VanGorder Residence (2024-088)

To the Town of Truckee Planning Commission:

I felt we all did a very comprehensive review of the project in the last meeting just leaving a short list of recommended edits. Please see below a list of those requested/recommended edits given to us by the planning department. Please see our response below in [Blue](#).

Proposed Typical 1:2 Window

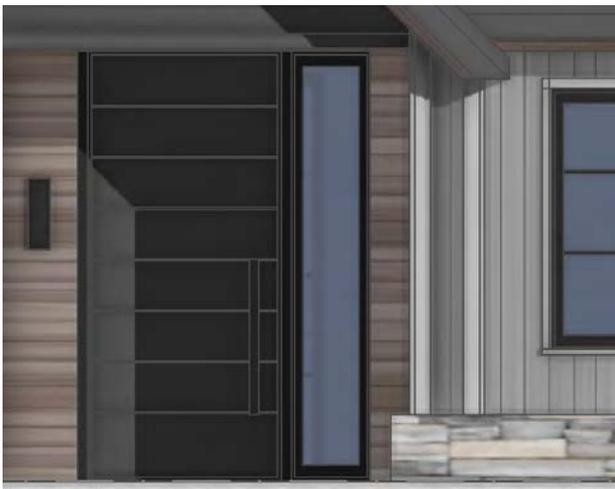
4. *Windows/glass: proportions 1/2 width to height, consistency in the window/door design across main level at rear elevation. No sliding glass doors/stackable glass doors.*

We revised all the window to have a true 1/2 width to height giving the whole house a more traditional and cohesive feel. We removed the sliding door system in the dining room and replaced them with the true 1/2 width to height windows. We added divided lights and breaks in the living room doors, so they read as windows when closed, giving the rear elevation more of a consistent language. We removed or reduced windows in all the following areas: Kitchen, Dining, both upper Bedrooms, Primary Bedroom and Bath, Mud Room, Garage, and Basement.
